STATE OF NORTH CAROLINA  
DEPARTMENT OF TRANSPORTATION

In reply, refer to  
File No. SC-2007-107  
SC-2007-108

**MEMORANDUM**

**SUBJECT:** Proposed Polks Landing and Williams Corner Developments on US 15-501  
Chatham County

## Access Option 1

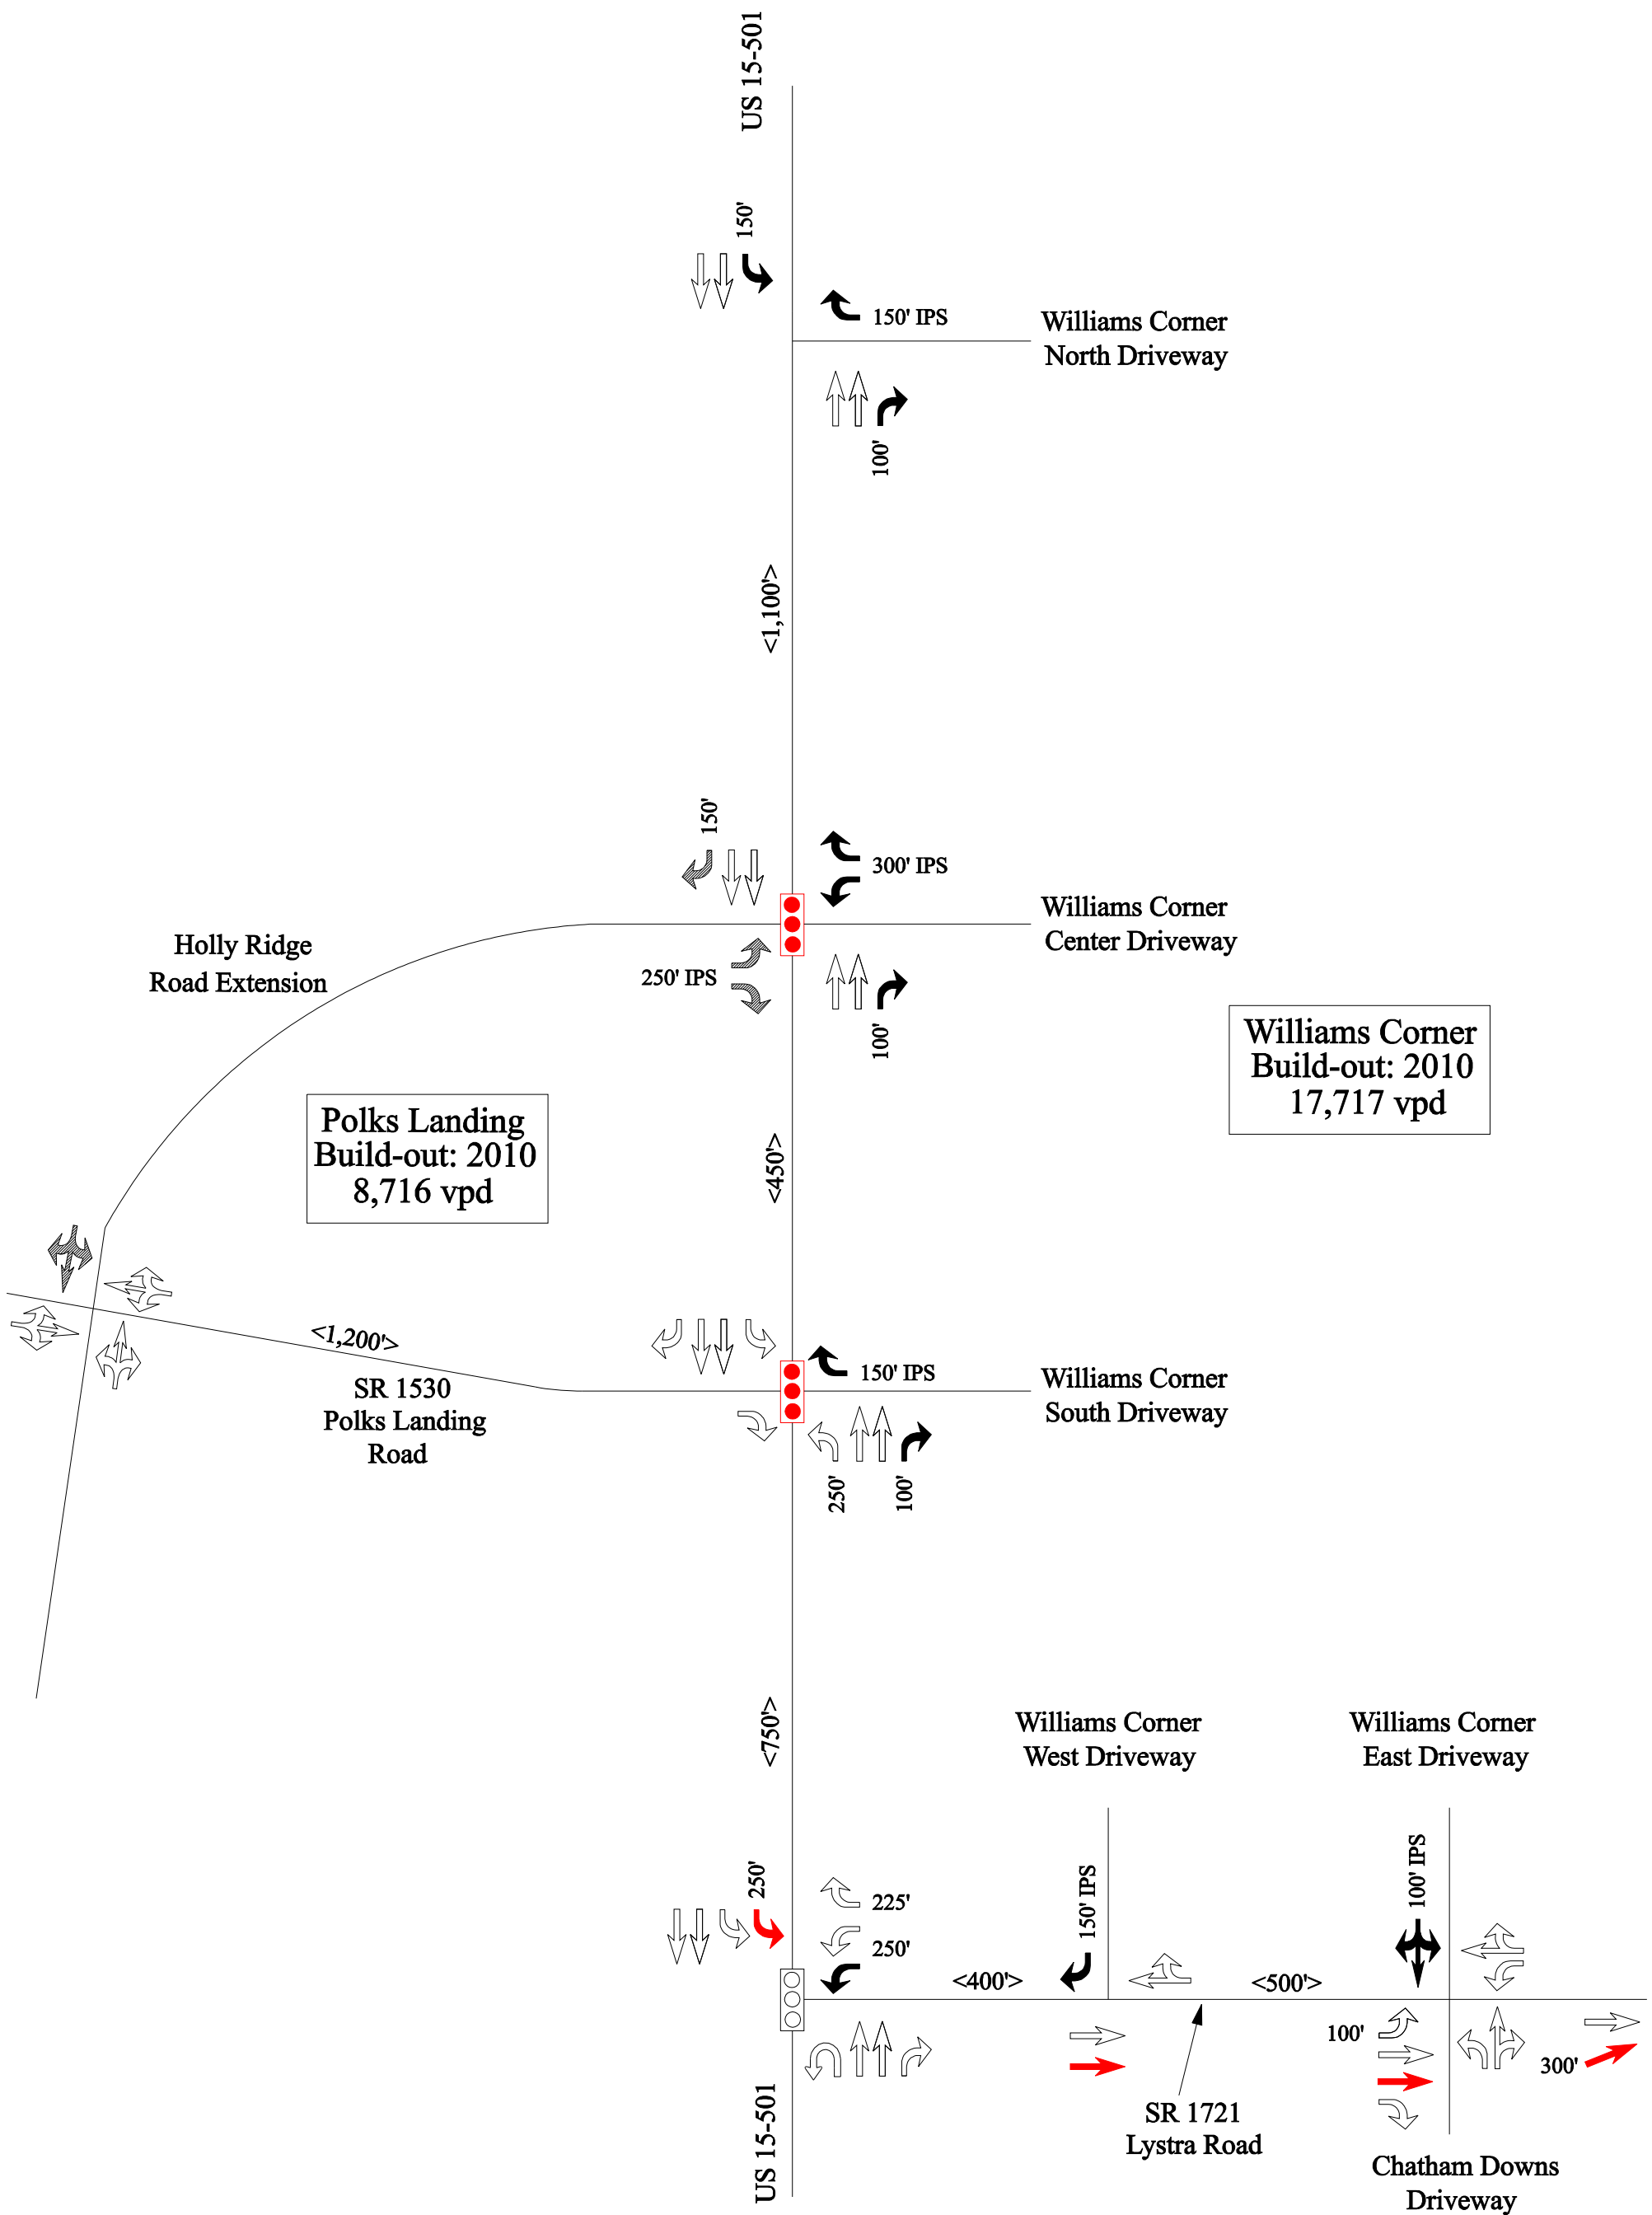
Due to the anticipated impacts that the additional site-generated traffic may have on this intersection, we recommend, with approval from the Regional Traffic Engineer and the Division Traffic Engineer, that this intersection be signalized. The following recommendations are based on a traffic signal in place.

- We concur with the TIA recommendation to provide a two-lane cross-section consisting of one ingress lane and one egress lane. The egress lane should provide for an exclusive right-turn lane only.
- The egress lane should provide a minimum of 150 feet of internal protected storage before parking and crossing maneuvers should be allowed. A concrete island should be provided to encourage exiting right-turn movements only.

- We concur with the TIA recommendation to provide an exclusive right-turn lane with 100 feet (minimum) of full storage and appropriate deceleration taper.

- We recommend providing an exclusive southbound left-turn lane with 300 feet (minimum) of full storage and appropriate transitional taper.
- A second feasible access scenario for the proposed Williams Corner Development is concurrence with the TIA recommendation to provide an unsignalized southbound leftover with 150 feet (minimum) of full storage and appropriate transitional taper at this intersection, and utilize the existing southbound left-turn lane at the proposed Williams Corner South Driveway to accommodate additional southbound left-turning vehicles entering the site.

- We recommend providing a three-lane cross-section consisting of one ingress lane and two egress lanes. The egress lanes should consist of an exclusive left-turn lane and an exclusive right-turn lane and provide 300 feet (minimum) of internal protected storage before parking and crossing maneuvers should be allowed.

- We concur with the TIA recommendation to provide an exclusive right-turn lane with 100 feet (minimum) of full storage and appropriate deceleration taper.

- We recommend providing a three-lane cross-section consisting of one ingress lane and two egress lanes. The egress lanes should consist of an exclusive left-turn lane and an exclusive right-turn lane and provide 250 feet (minimum) of internal protected storage before parking and crossing maneuvers should be allowed.

- We concur with the TIA recommendation to provide an exclusive right-turn lane with 150 feet (minimum) of full storage and appropriate deceleration taper.

Based on the anticipated traffic volumes, it appears that this intersection may meet signal warrants during or at full build out of the site; therefore, this intersection should be monitored for signalization. If signalization is required at the build-out of the developments, then the responsibility should be that of the Proposed Polks Landing Development.

- We concur with the TIA recommendation to provide a two-lane cross-section consisting of one ingress lane and one egress lane. The egress lane should consist of an exclusive right-turn lane only.
- The egress lane should provide a minimum of 150 feet of internal protected storage before parking and crossing maneuvers should be allowed. A concrete island should be provided to encourage exiting right-turn movements only.

- We concur with the TIA recommendation to provide an exclusive right-turn lane with 100 feet (minimum) of full storage and appropriate deceleration taper.

- Due to the right-in/right-out conditions recommended for the Proposed Williams Corner South Driveway, we recommend prohibiting the existing left-turn/U-turn movement at this intersection. Vehicles anticipated to make this movement should be accommodated by the left-turn/U-turn at the downstream intersection with SR 1721 (Lystra Road).
- As previously mentioned, a second access alternative would be to utilize the existing southbound left-turn lane at this location to provide access to the proposed Williams Corner Development. It should be noted that if this option is chosen, we recommend, with approval from the Regional Traffic Engineer and the Division Traffic Engineer, that this intersection be signalized with a two phase signal design.

- Due to the right-in/right-out conditions recommended for this approach, left-turns will be prohibited. Vehicles anticipated to make this movement should be accommodated by the downstream intersection with SR 1721 (Lystra Road).

- We recommend extending the existing exclusive left-turn lane to provide 250 feet (minimum) of full storage and appropriate transitional taper.

- We recommend providing dual left-turn lanes with 250 feet (minimum) of full storage and appropriate transitional taper.
- We concur with the TIA recommendation to extend the existing right-turn lane to provide 225 feet (minimum) of full storage and appropriate deceleration taper.

- We recommend providing dual left-turn lanes with 250 feet (minimum) of full storage and appropriate transitional taper.
- To accommodate the dual left-turn lanes, dual receiving lanes will be required on the eastbound SR 1721 (Lystra Road) departure. We recommend full storage for the additional receiving lane extend a minimum of 1,200 feet with appropriate transitional taper.

- We concur with the TIA recommendation to provide a two-lane cross-section consisting of one ingress lane and one egress lane. The egress lane should consist of an exclusive right-turn lane only.
- The egress lane should provide a minimum of 150 feet of internal protected storage before parking and crossing maneuvers should be allowed. A concrete island should be provided to encourage exiting right-turn movements only.

- We concur with the TIA recommendation to provide a two-lane cross-section consisting of one ingress lane and one egress lane. The egress lane should consist of a combination through/left-turn/right-turn lane and provide a minimum of 100 feet of internal protected storage before parking and crossing maneuvers should be allowed.

- We concur with the TIA recommendation to provide an exclusive left-turn lane, however we recommend providing 100 feet (minimum) of full storage and appropriate transitional taper.

- We concur with the TIA recommendation to provide a two-lane cross-section consisting of one ingress lane and one egress lane. The egress lane should consist of a combination through/left-turn/right-turn lane and provide 100 feet (minimum) of internal protected storage before parking and crossing maneuvers should be allowed.
